18 November 2024

1233 Yonge Street and 9 Woodlawn Avenue East
Official Plan and Zoning By-Law Amendment Application

03 January 2024

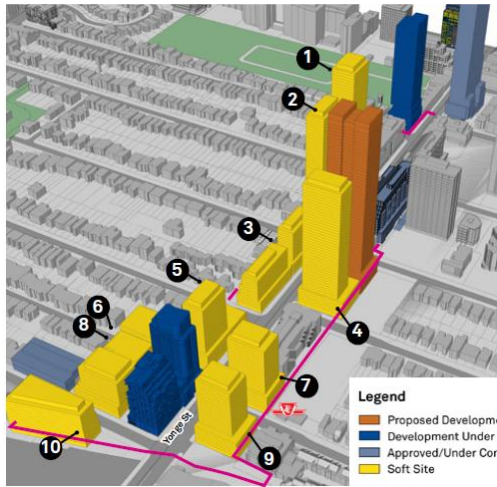
Further to my letter of 03 January 2024 (attached) and based on a developer's briefing of the *Summerhill Residents Association* on 16 October 2024, followed by a careful review of the documents filed on 28 October 2024, I have concluded that the revised proposal (see next page) of a 52-storey tower with 763 units on a 0.19 ha lot is deficient, as follows:

5. **Tall Building Design Guidelines ("TBDG")** issued under to OP-policy 5.3.2.1): It does not follow guidelines on floor plate size, minimum setbacks, and transition in scale.

Accordingly, I recommend that this application be refused until substantial conformity with the Official Plan - the main vehicle to implement the PPS - has been established.

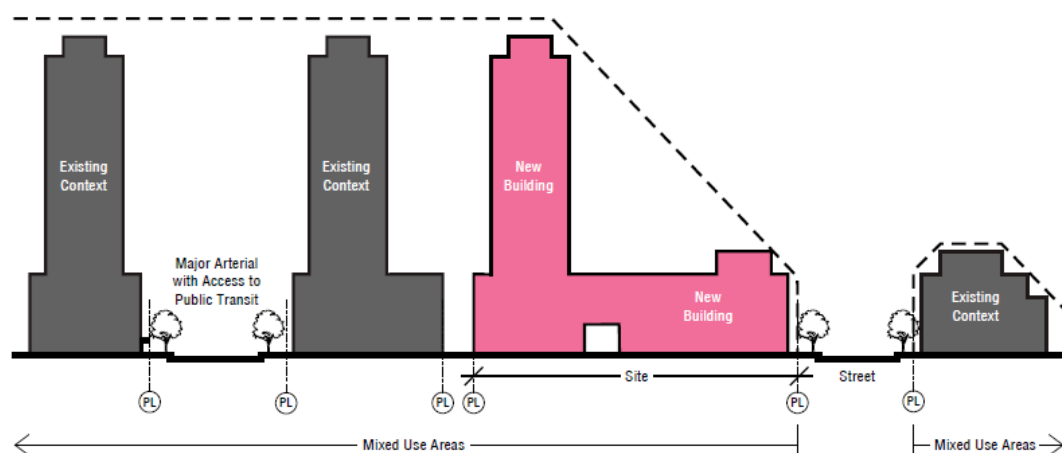
The transition in scale to the *Neighborhood* is to be accommodated on the tower site itself (88° angular plane) – not by imposing on the adjacent TTC-property (72° angular plane) leased by 7 Jackes as condition of its Zoning By-law, or even of the residential properties along Woodlawn and Summerhill (45° angular plane).

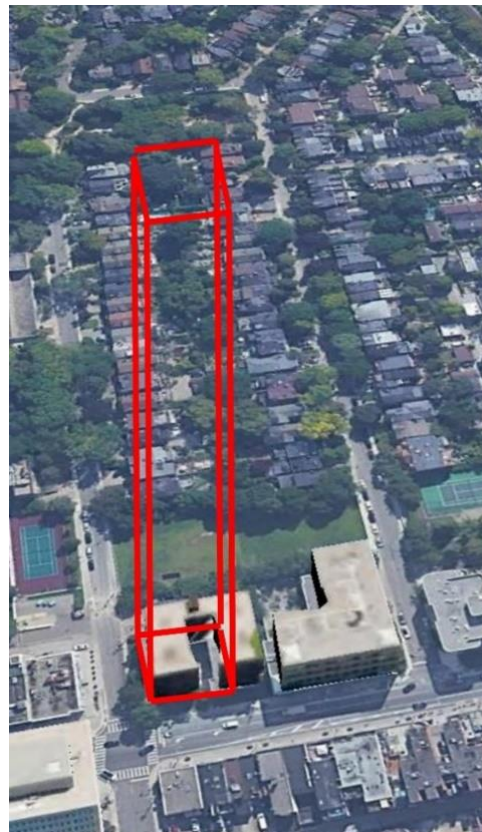
Increasing the minimum tower setback on the east from 5.5 m to the recommended minimum of 12.5 m and the tower setback to the south from the proposed 10.0 m to the recommended minimum of 12.5 m would reduce the floor plate from the proposed 998.6 m² - which is in excess of the recommended maximum of 750 m² by 33% - to a more reasonable 780 m². This is a tiny site of 0.19 hectares.

TBDG Section 3.2.3: “On small sites, apply the recommended minimum tower setbacks and setbacks to determine the resultant floor plate size and feasibility of the site dimensions to accommodate a tall building.”
